PINNACLE AT LIBERTY BAY PRD

RE: Pinnacle at Liberty Bay – P-06-20-25-03 – Retaining Wall Design & Maintenance and Landscaping Coordination Response

RE: Pinnacle at Liberty Bay – P-06-20-25-03 –Individual Identity Plan Narrative and Elevations

Encl. Figure 1

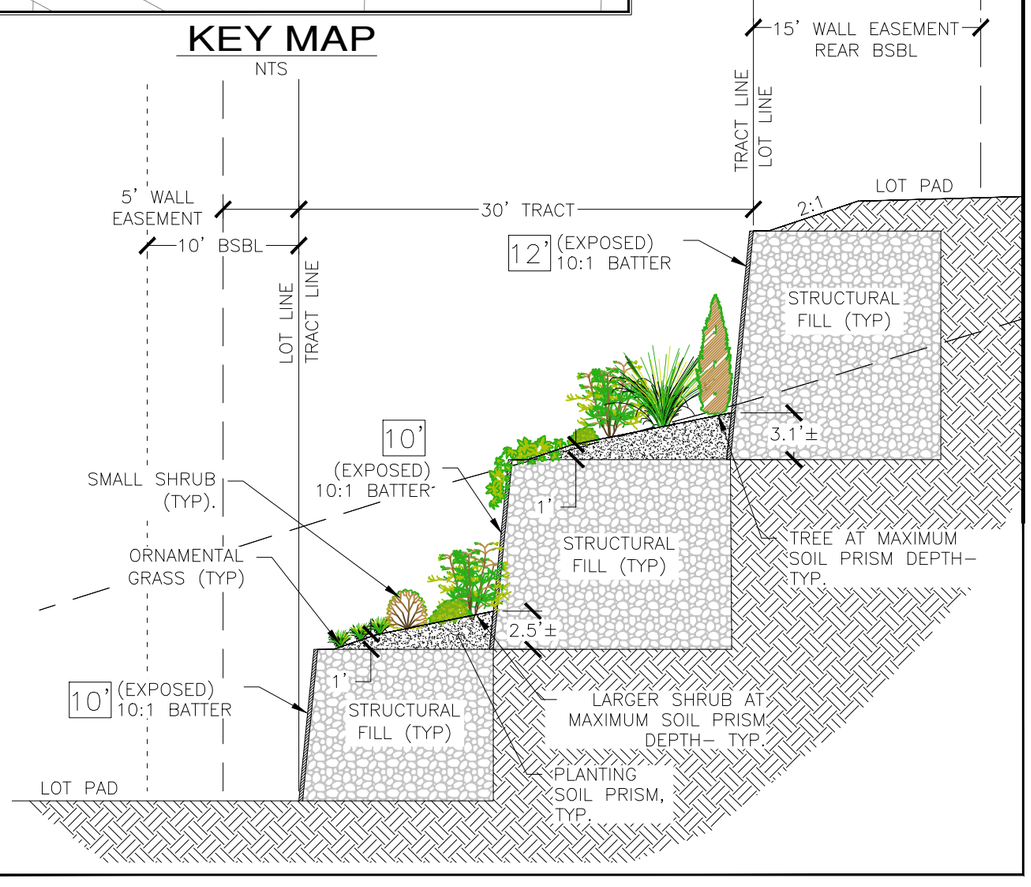
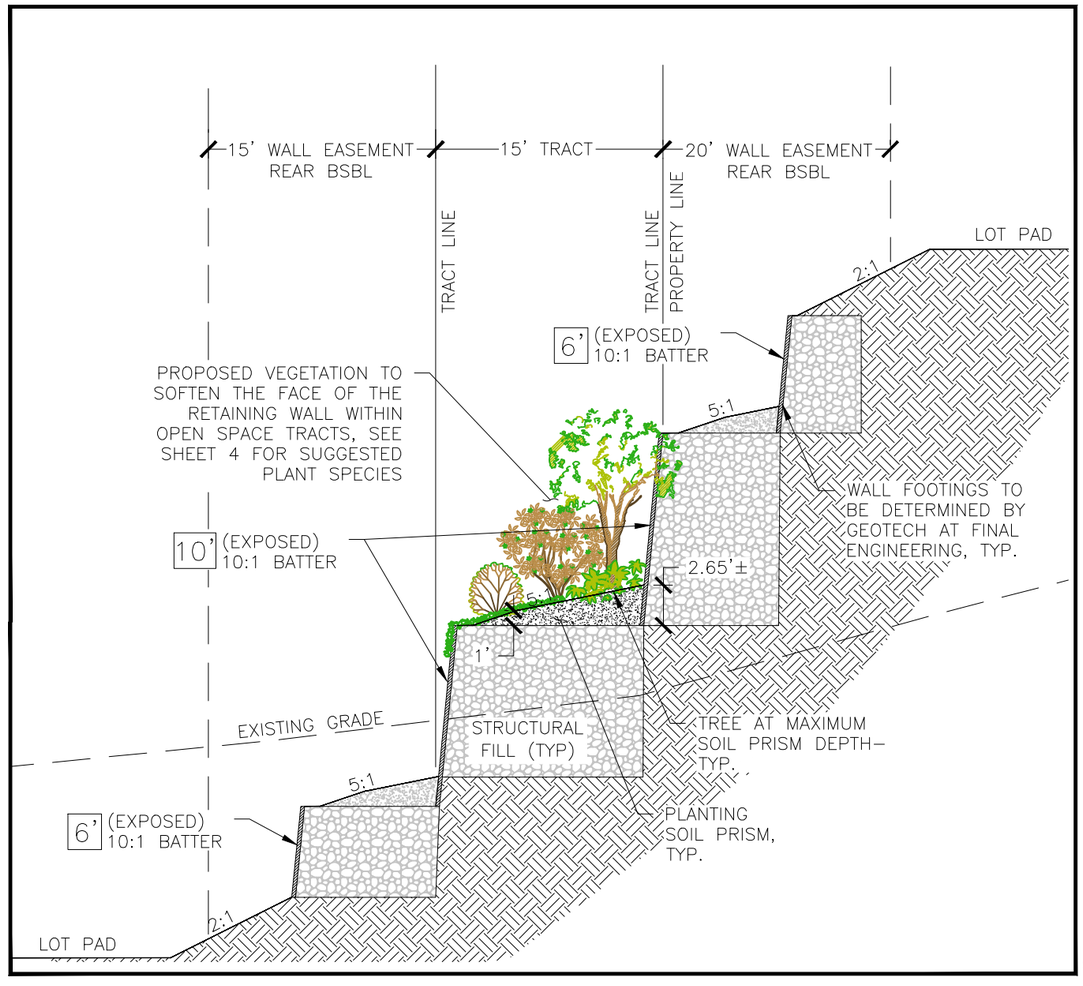
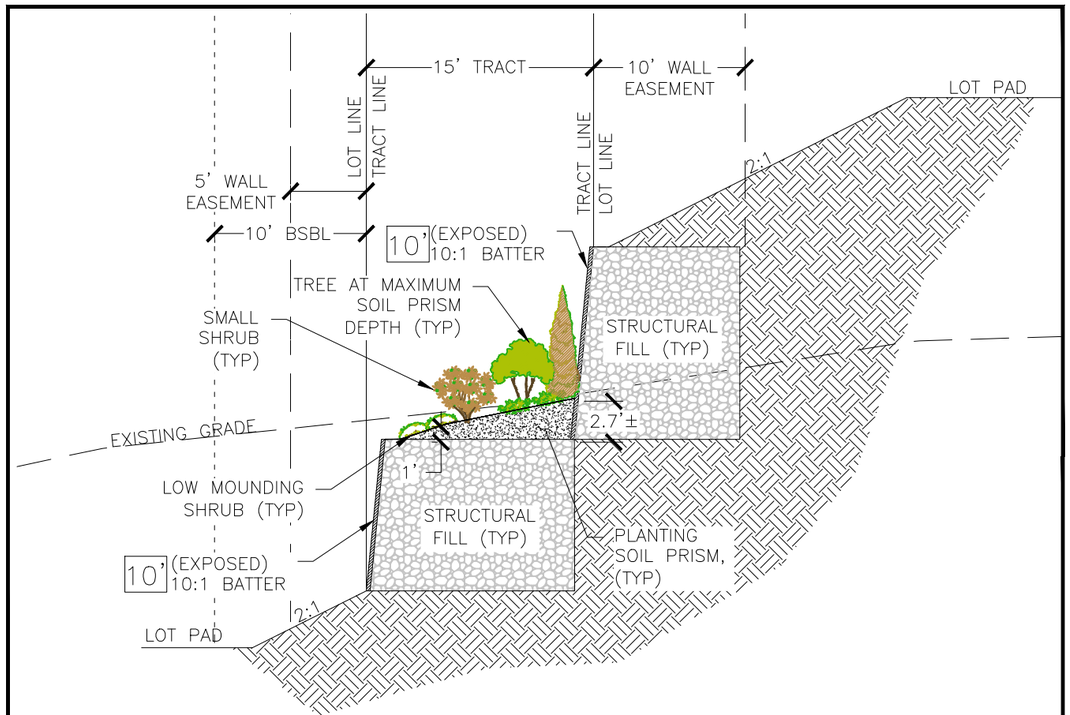
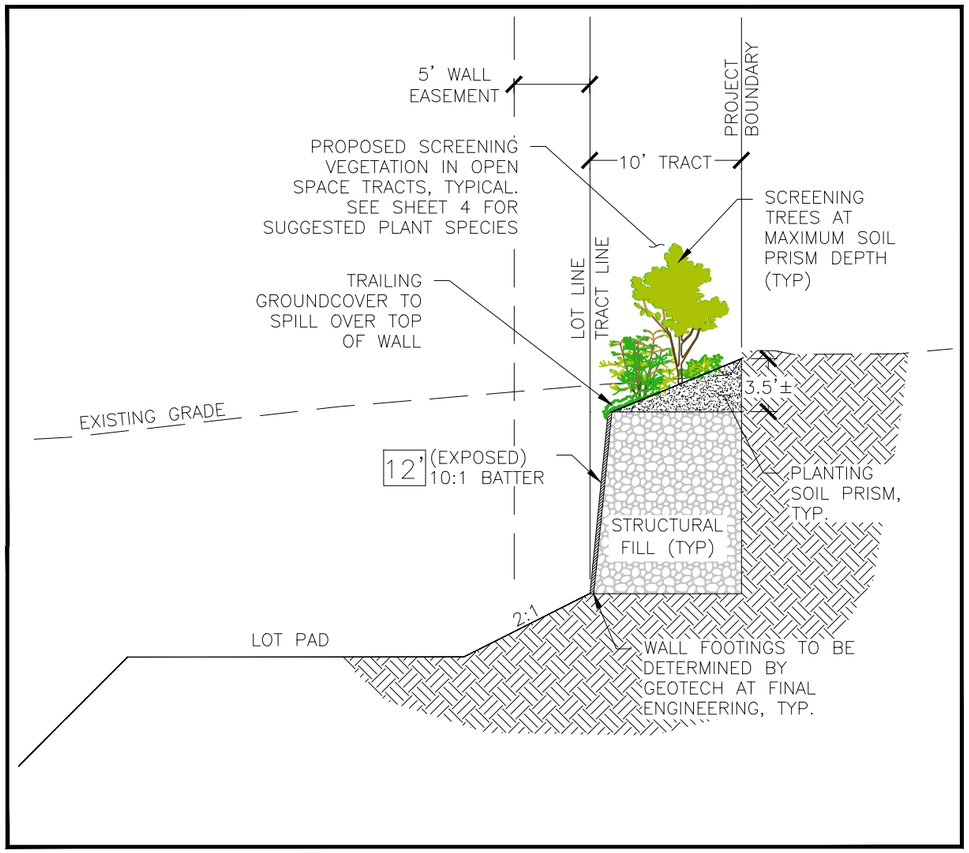
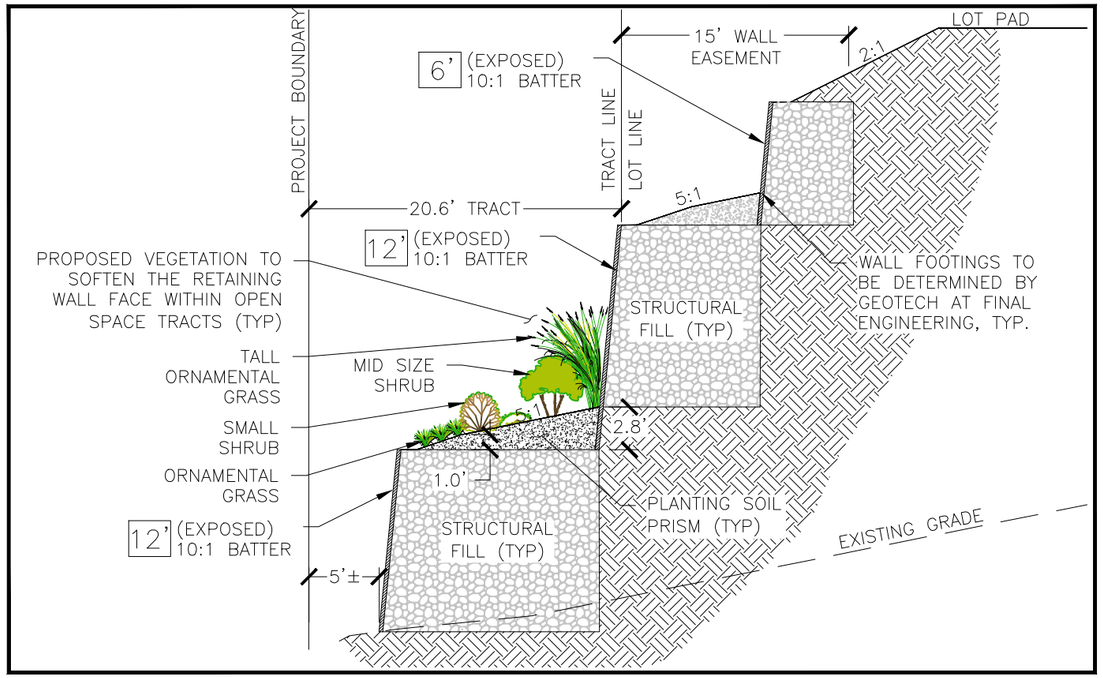
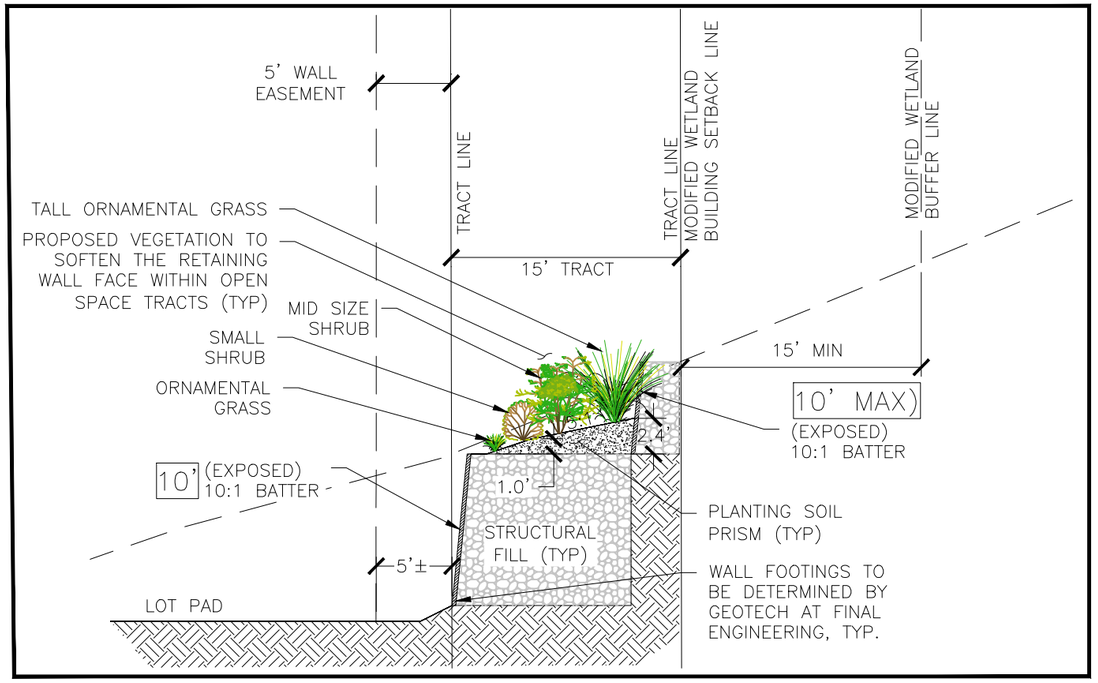
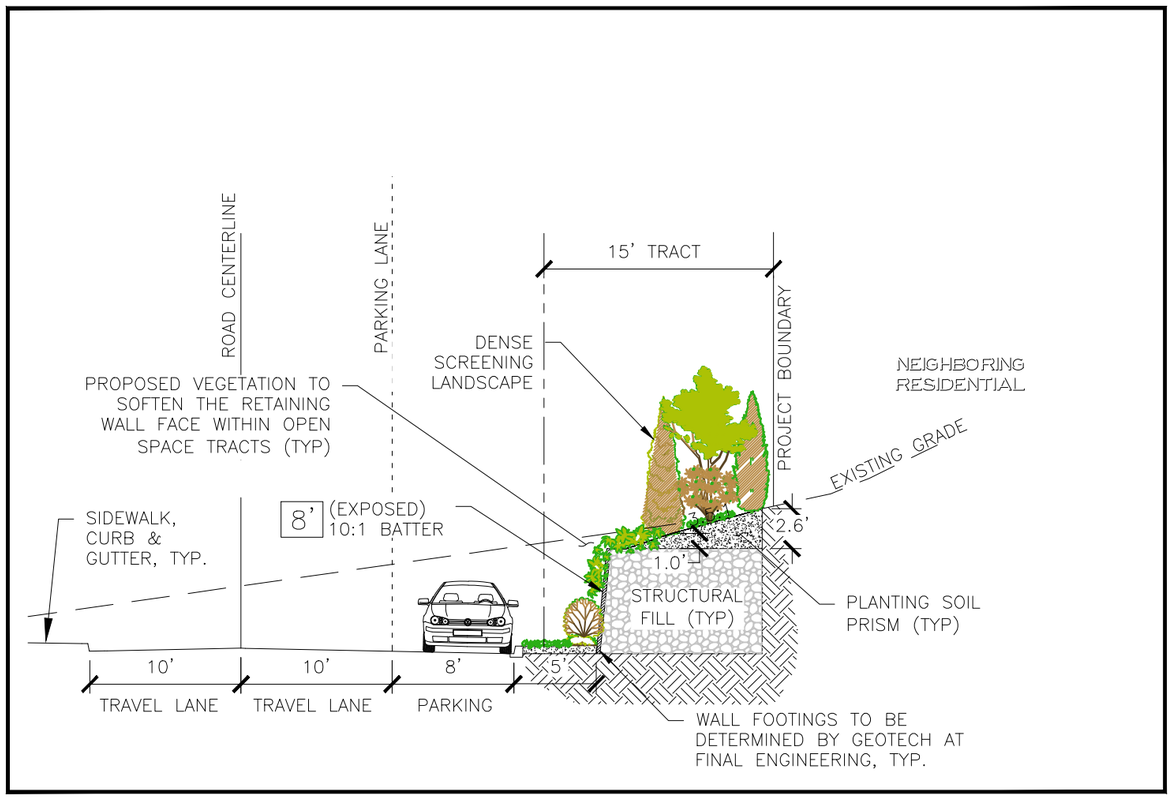
- **Road B Parking Adjacent to walls:** Parallel parking stalls are proposed along the east side of Road B adjacent to a proposed retaining cut wall. As detailed on Sheet 4 of the Encl. Figure 1, the retaining wall proposed along Road B provides a sufficient horizontal separation distance of 5 feet between the parallel parking stalls and the adjacent wall face. A vertical curb is incorporated directly along the parking edge and will prevent vehicles from parking closer than 5 feet from the wall.

At the tiered wall areas, Encl. Figure 1 shows the planting space available between wall tiers. Planting will only be installed where there is adequate room for the proposed material, including proper soil volume and separation from the wall structure and drainage system.

Landscaping has been provided next to retaining walls where space allows, as shown on Encl. Figure 1. The intent is to break up and soften the appearance of exposed wall faces while maintaining space needed for the retaining walls, utilities, drainage, and maintenance access.

The sections on Encl. Figure 1 show that planting between retaining wall tiers can be accommodated and maintained where adequate planting space and soil volume are available. Planting will not be placed within wall foundation areas, drainage aggregate zones, subdrain areas, or required maintenance areas.

Preliminary Architectural Elevations - July 15, 2025

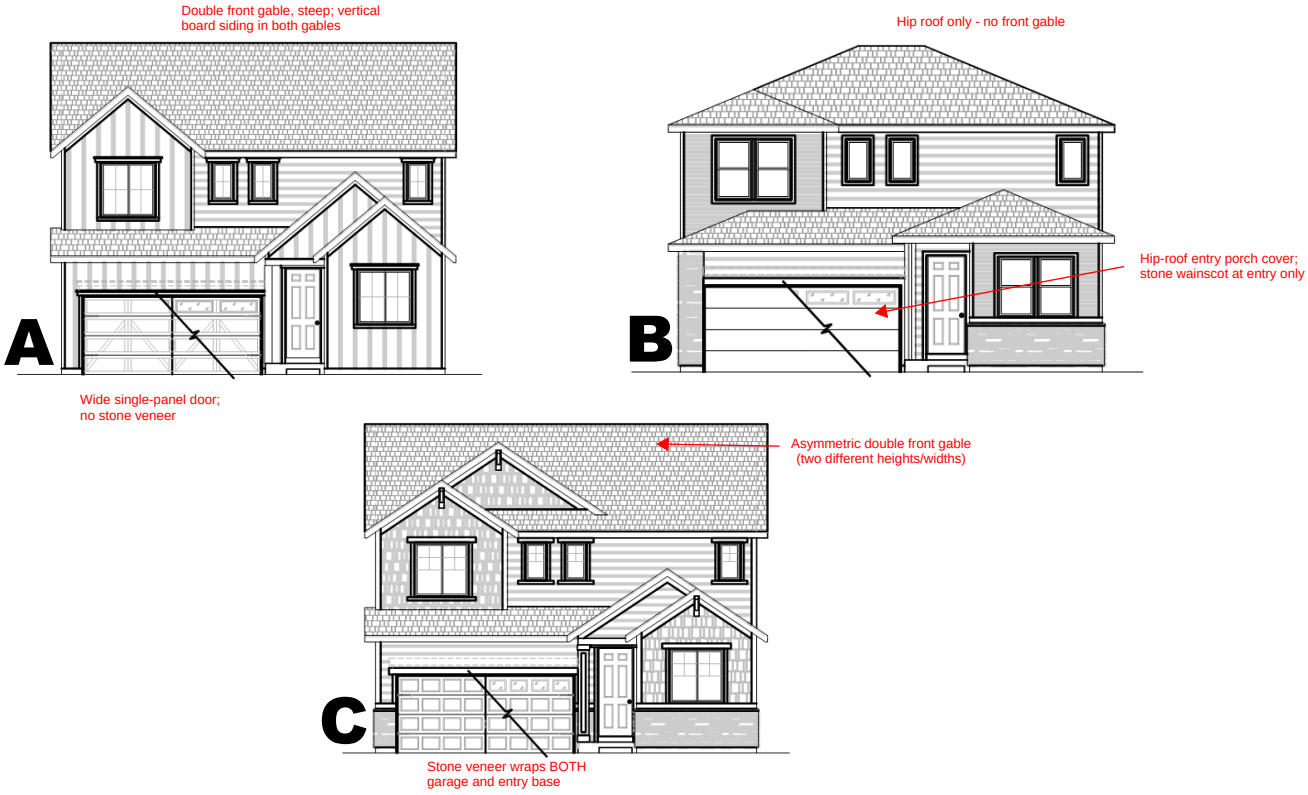
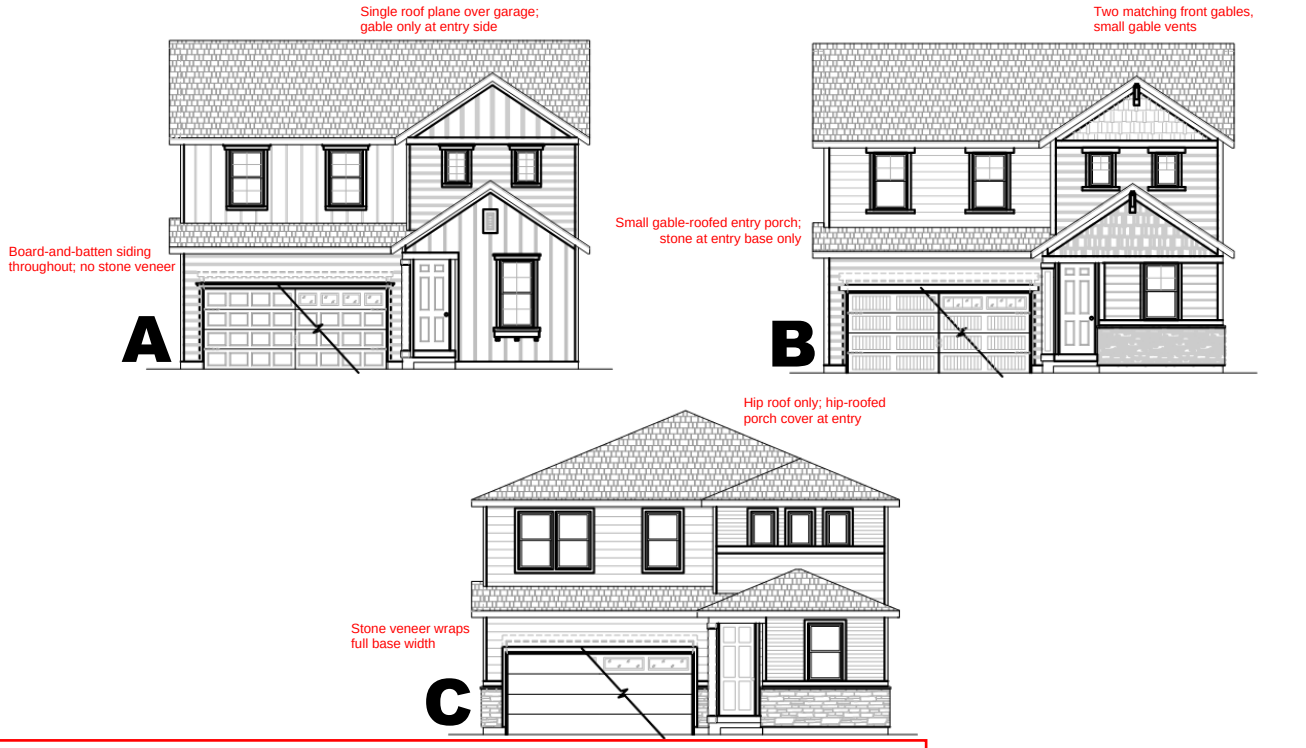
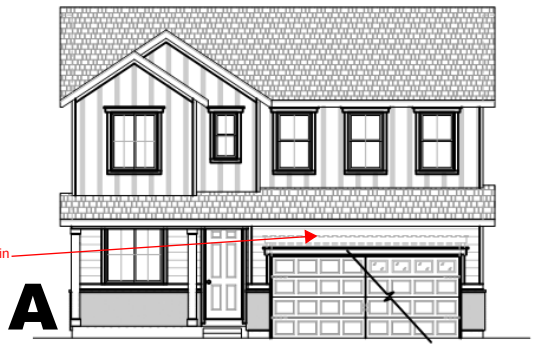
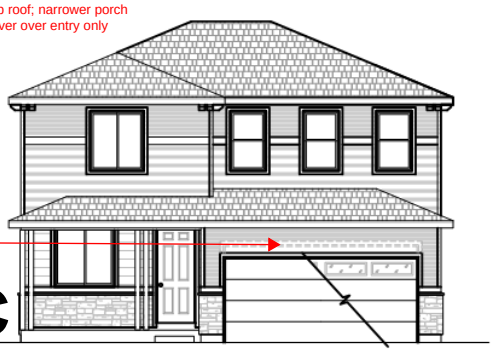
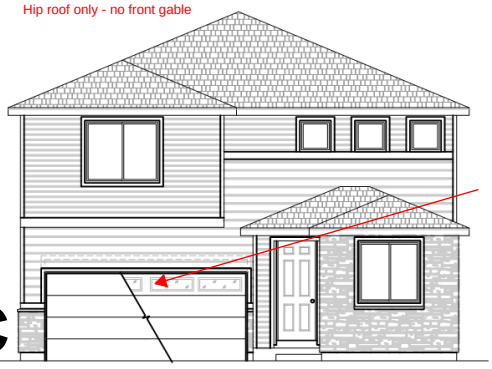
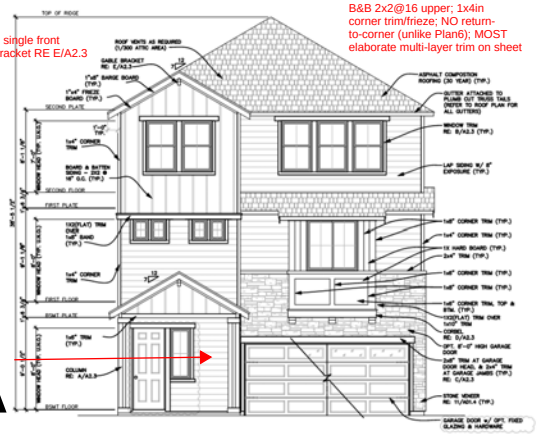
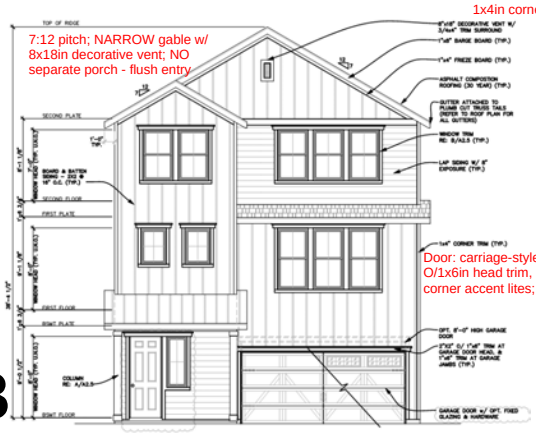
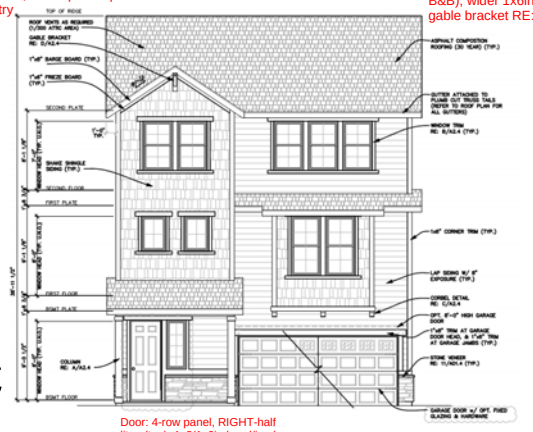
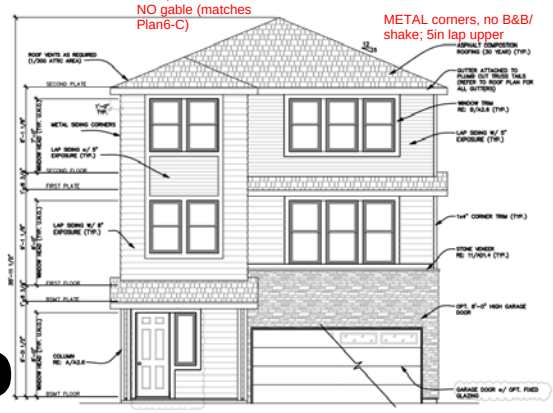
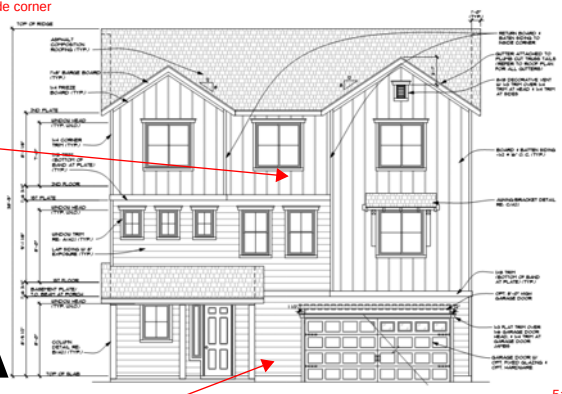
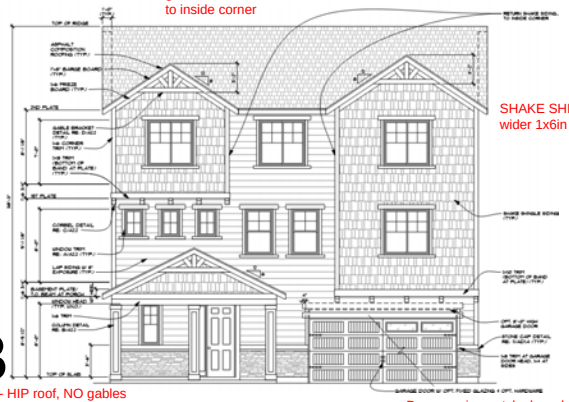
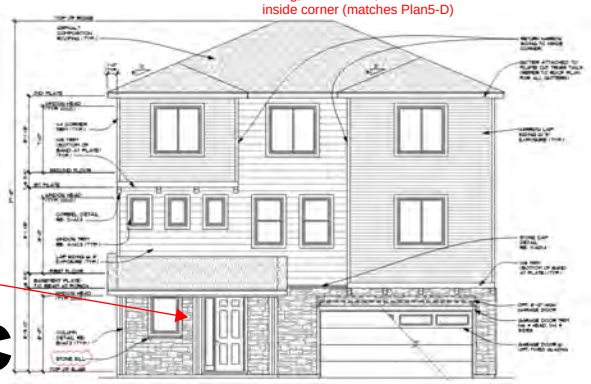
4. Many of the proposed home designs appear similar in overall form and architectural treatment. Please provide a detailed narrative demonstrating how each proposed elevation achieves distinct visual differentiation in compliance with PMC 18.260.060(F). For example, several "B" and " " elevations across Plans 1-4 appear to repeat similar design elements with minimal differentiation. The narrative should clearly identify how each elevation varies in building form, rooflines, façade articulation, materials, colors, and architectural details, and how these differences meet the intent of providing visual variety across the subdivision. This item can be conditioned to be due prior to the first building permit submittal.

The proposed elevations differ through more than four of the design elements listed in the code. The supporting elevation sheets and Enclosure 1 show variation in roof form and pitch, façade articulation, porch and entry treatment, garage design, window placement, exterior materials, and color.

PMC 18.260.060(E)(2)(b)(ii) – Façade Articulation
The elevations include different wall planes, porch projections, entry projections, recessed entries, garage projections, and changes in overall façade composition. These features add depth to the front elevations and avoid a flat or repetitive appearance.

PMC 18.260.060(E) response letter: ROOF FORM/PITCH - "Roof configurations and silhouettes vary... including differing front-gable conditions, ridge arrangements, and massing between plans." GARAGE PLACEMENT - "Garage width and position...differ from plan to plan...a tuck-under condition inherently changes massing and garage prominence relative to a flat-lot condition."
